TOWN OF PORTOLA VALLEY

1. Preliminary Architectural Review of an addition/remodel at 3915 Alpine Road- Alpine Inn; File # PLN_ARCH0022-2021 (J. Garcia)

SUBJECT: Preliminary Architectural Review of an addition/remodel at 3915 Alpine Road- Alpine Inn.

TITLE
PROPOSED FLOOR PLAN & ROOF PLAN, STORY POLE PLANS

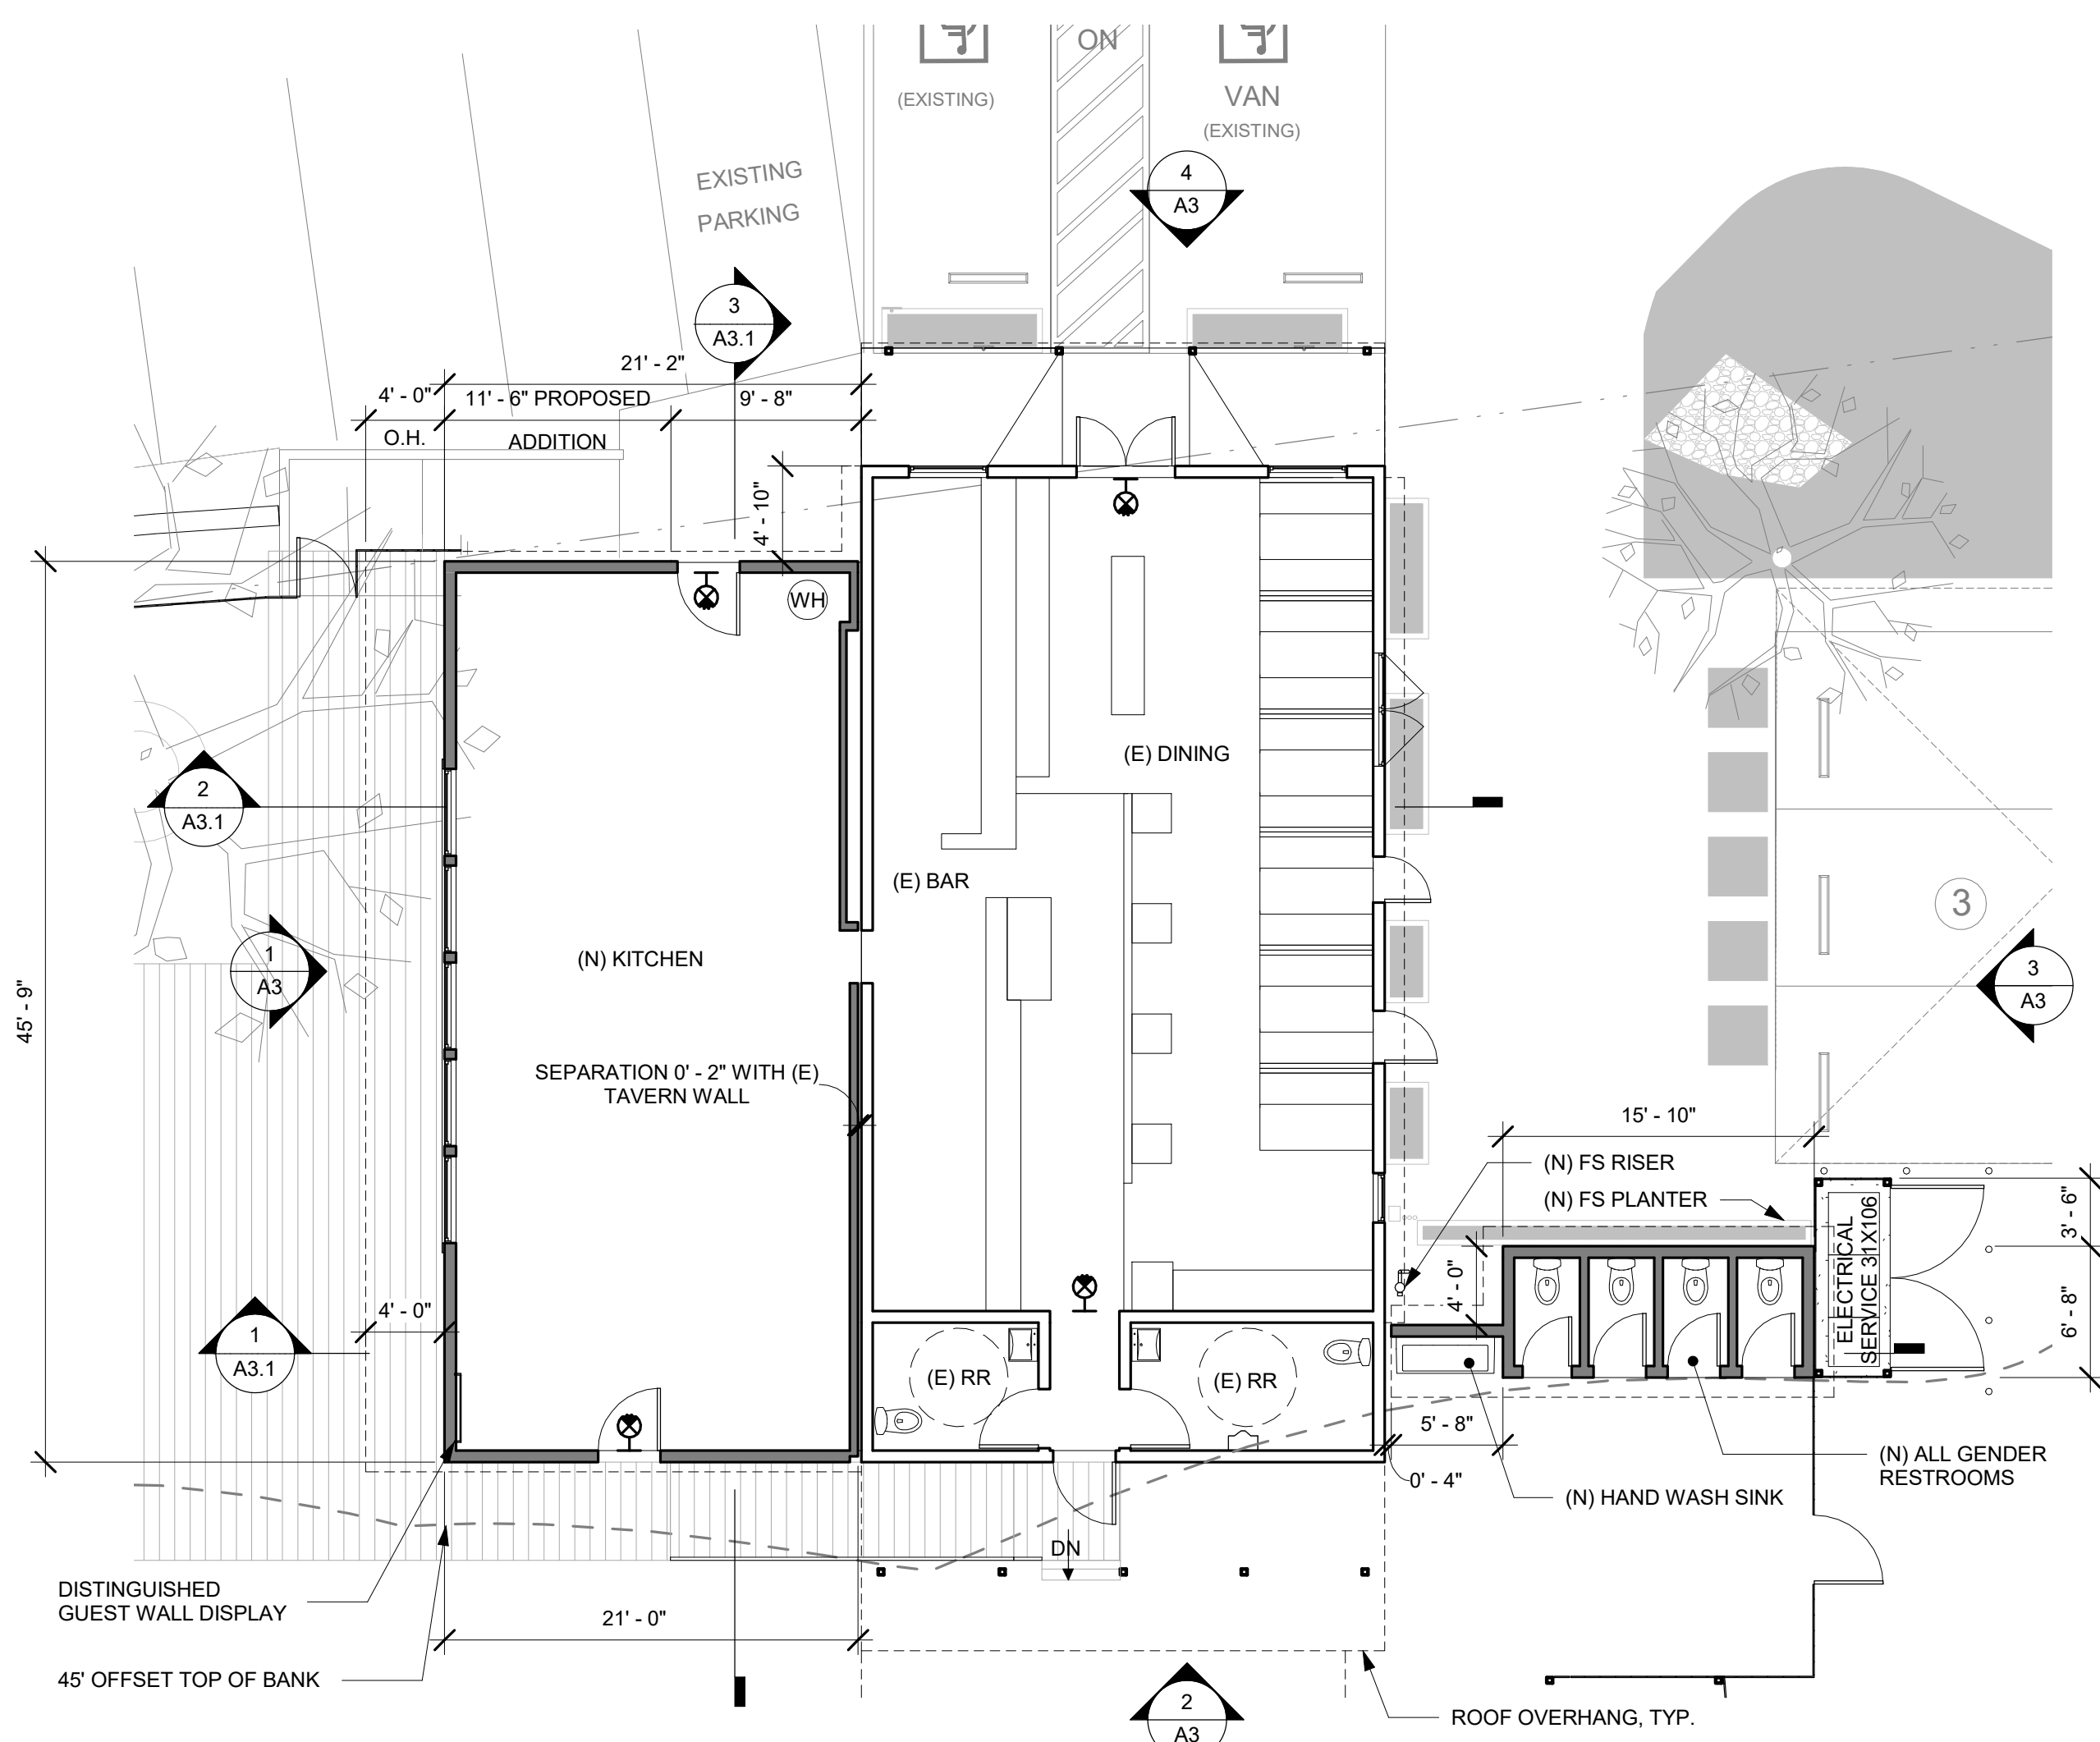
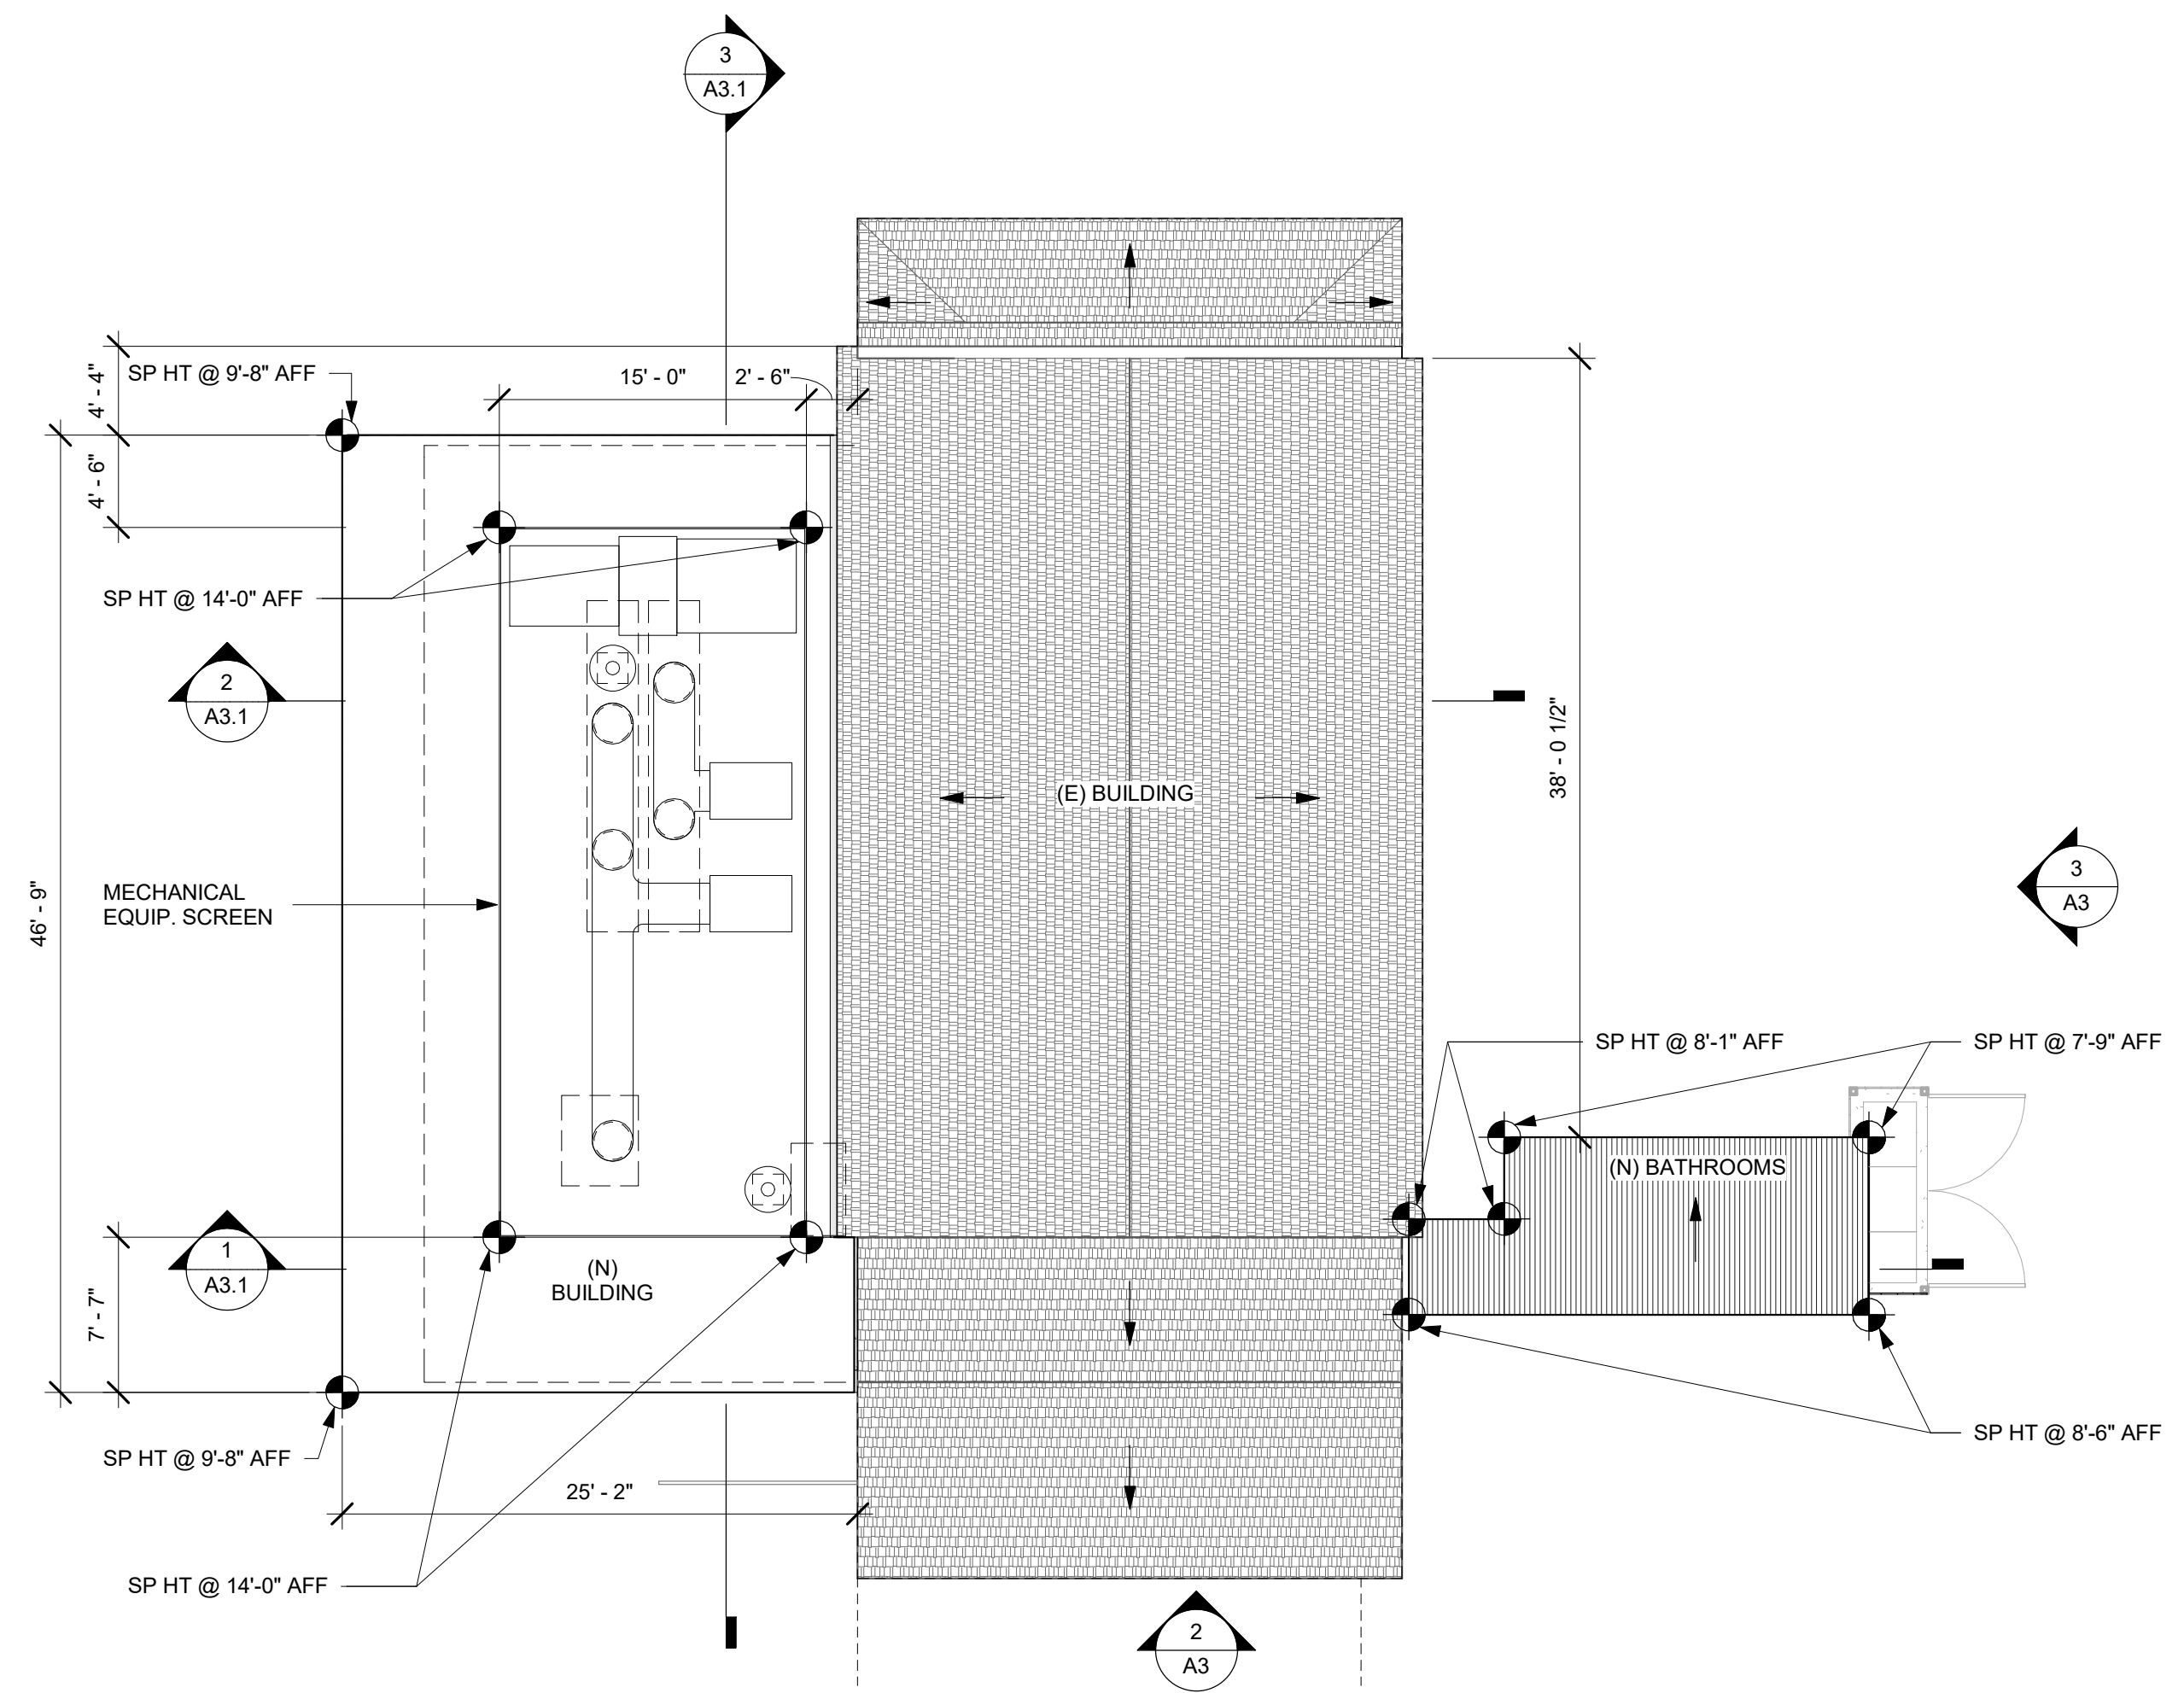
On December 9, 2021, the applicant submitted an application for architectural review of an 968 square foot addition to the existing Alpine Inn restaurant, 3915 Alpine Road. The project includes demolition of site features with some minor site improvements. The application was deemed complete on January 26, 2023. Story poles were installed on March 02, 2023. The story pole plan is included in project plans (Attachment 1, Sheet A2)).
